ENVIRONMENTAL HEALTH \$ERVICES

STID: 1287

Re: Investigations at Dreyers Grand Ice Cream, located at 5929 College Avenue, Oakland, CA

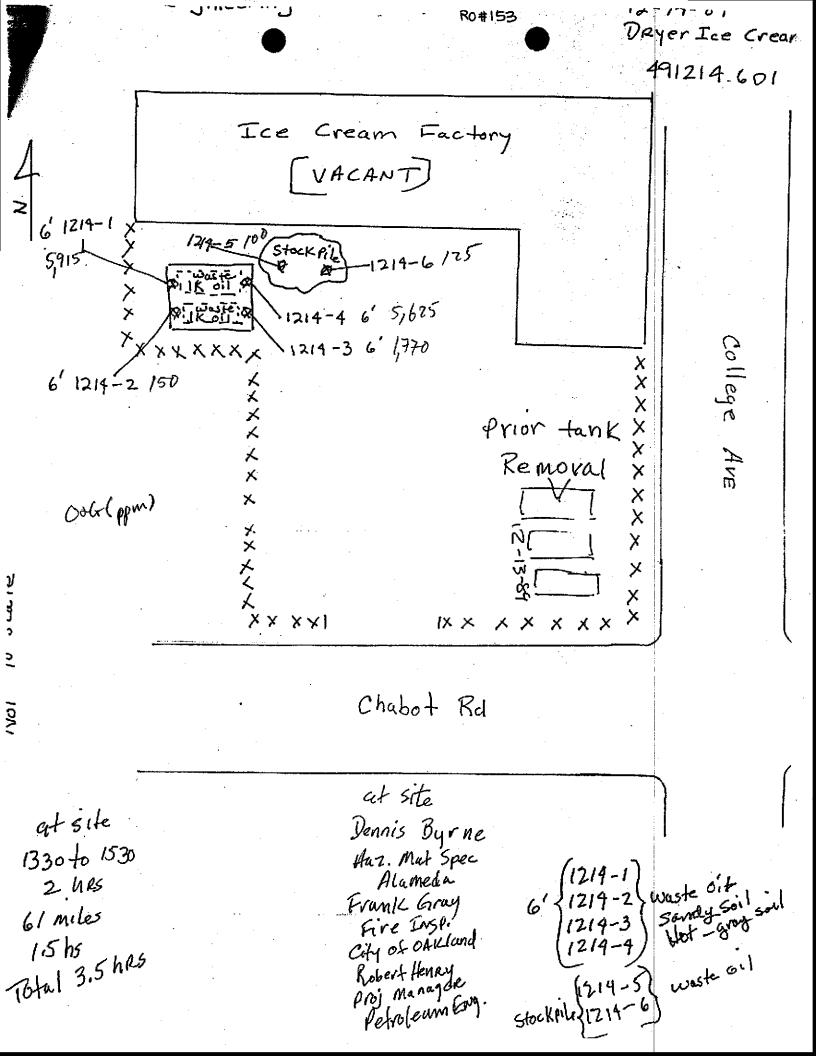
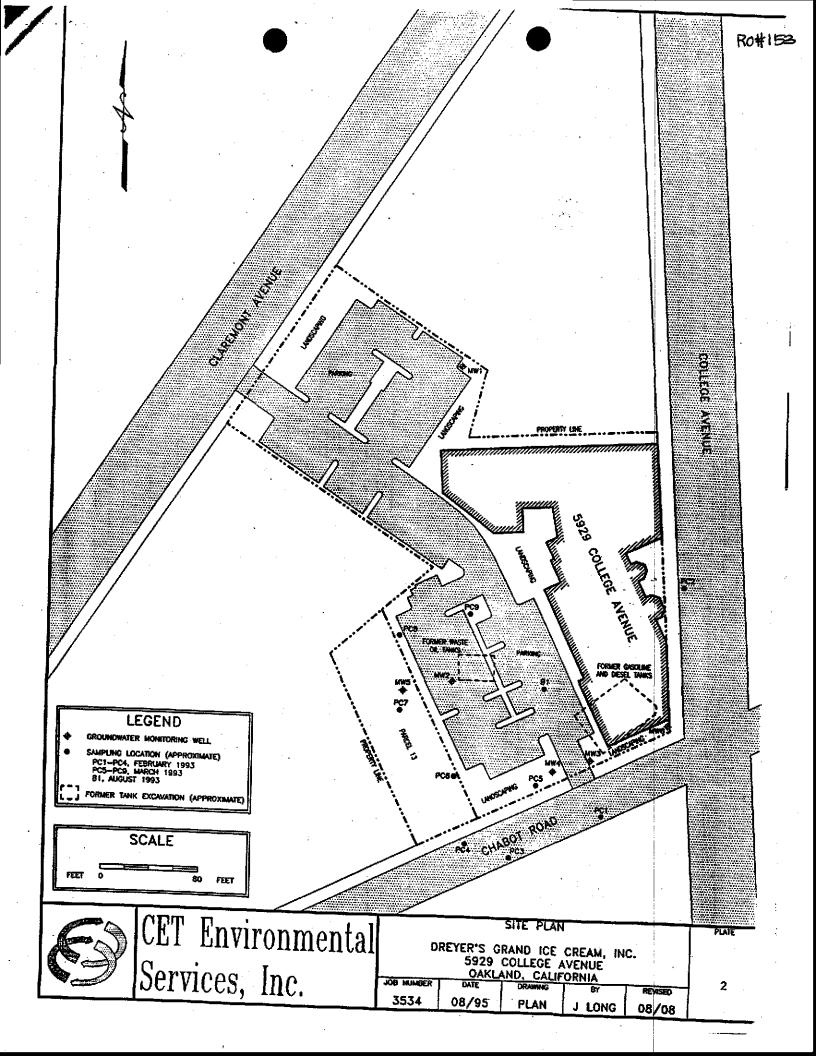
Based on the elevated contaminant concentrations observed in the site's monitoring wells, nine exploratory hydropunch borings (PC1 through PC9) were emplaced around the site to investigate the lateral extent of contamination. Complications arose when attempts were made to collect groundwater samples from these boring locations and the bulk of the borings came up dry. Also, the analytical results of soil and groundwater samples collected from these borings did not appear to be representative since the results showed low to NonDetect concentrations in areas that were later found to contain elevated concentrations in groundwater (in Wells MW-4 through MW-6) (Refer to attached figure of boring and well locations).
